Model Royal 43 S

Some of the above named lawn mowers can lose their drive capacity due to the belt slipping. If this cannot be adjusted using the wire it can be due to adverse belt tolerances or the cutting deck. One way to increase the tensioning possibilities of the belt is to remove material from the sleeve around the gearbox's tensioning spring.

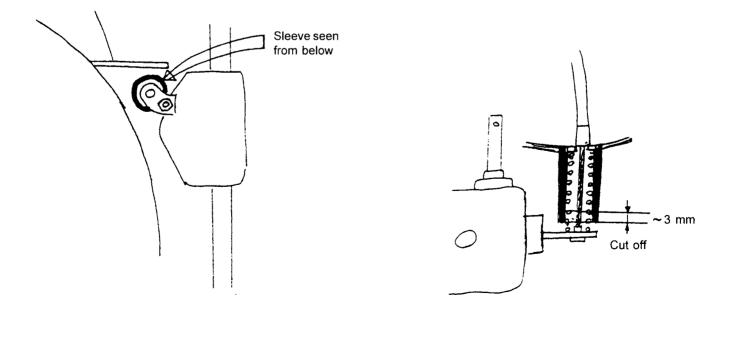
- Empty the oil and fuel.
- Remove the belt and belt pulley.
- · Loosen the wire from the gearbox and remove the spring.

• Remove the rear wheel suspension (it is best to remove the bearing cover and then fold back the rear wheel suspension to avoid replacing the start lock washer on the height adjustment stay).

- Cut approx. 3 cm off the sleeve (chisel, sharp knife or any other tool can be used).
- Reassemble
